# Integra Apparels (Bangladesh) Ltd- Extension

# Building Information

# Observations

# **Lack of lateral stability of roof shed**

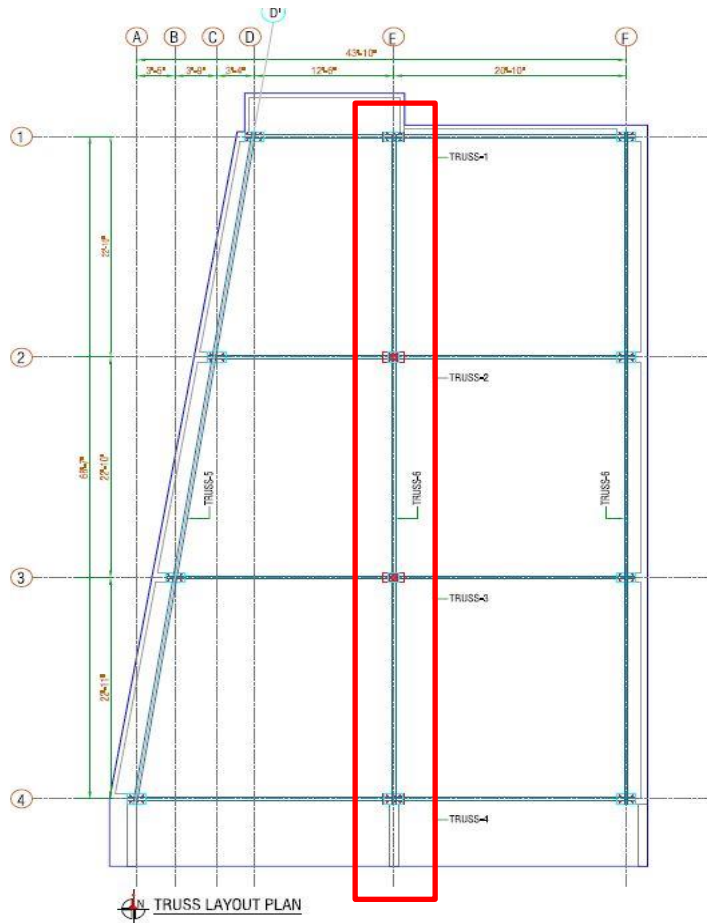
No lateral bracing system provided for roof shed

No lateral framing provided for the truss frame to transfer the lateral load in long direction. Building engineer is required to check the lateral stability of the roof shed.

| Item No. | Observation                                                        | Recommended Action Plan                                                                                                                          | Recommended Timeline |
|----------|--------------------------------------------------------------------|--------------------------------------------------------------------------------------------------------------------------------------------------|----------------------|
| 03       | Lack of lateral stability of roof shed. (Extension Building)       | Building engineer is required to check the lateral stability of the roof shed and suggest necessary remedial action.                             | 6-weeks              |
| 04       | Lack of lateral stability of roof shed. (Extension Building)       | Implement suggested remedial work where required.                                                                                                | 6-months             |

# **Non-structural elements found unbraced/not anchored**

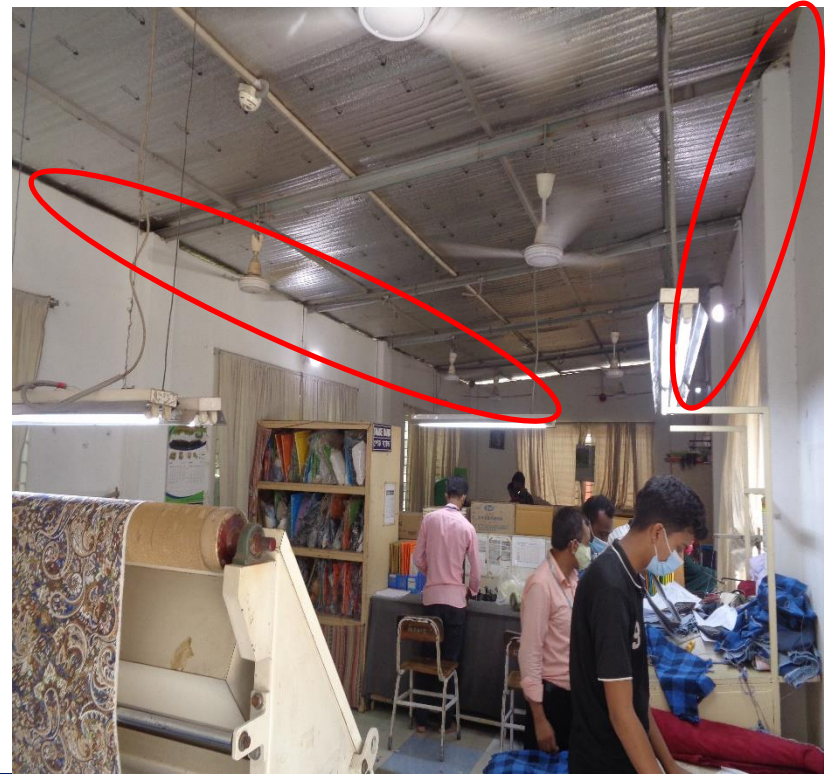
Storage rack found within the building without braced/anchored

Building engineer is required to brace/anchor all non structural elements.

| Item No. | Observation                                                              | Recommended Action Plan                                                                                          | Recommended Timeline |
|----------|--------------------------------------------------------------------------|------------------------------------------------------------------------------------------------------------------|----------------------|
| 09       | Non-structural elements found unbraced/not anchored (Extension Building) | Building engineer is required to brace/anchor all nonstructural elements.                                        | 6-weeks              |
